Vport ad hoc SOA D0.9 comment resolution and PSE Current Requirements

October 2007

D0.9 Comments 178, 137

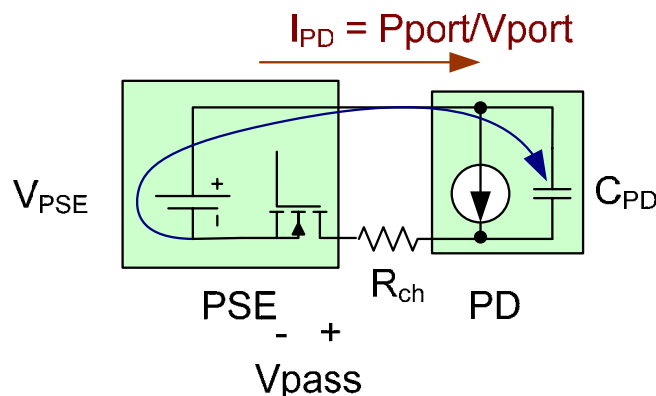
- Page 25, line 50
- “A PSE in the power on state may remove power from the PI when the PI voltage no longer meets the Vport specification.”
- Add San Francisco due to a Vport ad hoc motion
All present; Y: 30 N: 0 A: 4
802.3; Y: 19 N: 0 A: 0 => PASS

The requirement that "A PSE in the power on state may remove power from the PI when the PI voltage no longer meets the Vport specification" essentially negates the broader purpose of specifying I_{inrush} , I_{lim} , and I_{lim} elsewhere in the specification. PSE's that enter a current limiting state, as defined by I_{inrush} , I_{lim} , and I_{lim} will in all likelihood drop below the Minimum Vport level since they are functioning as current sources (400 to 450mA), not voltage sources in this mode. This behavior is time-bounded by T_{lim} , of course.

Since I_{inrush} , I_{lim} , and T_{lim} provide robustness within PoE to handle marginally compliant transient overload conditions, it seems unwise to undermine those requirements with this clause. Also, 33.2.8.8 now adds further criteria ("SOA" Type 2 PSE's) for removing power based upon transient overload current designed to protect PSE's and interconnect integrity. The relevance of that criteria would be undermined by this particular clause.

Finally, this clause is simply inconsistent and contradictory with 33.2.8.8 b).

- **Leave text as is.**
- **All present; Y: ? N: ? A: ?**
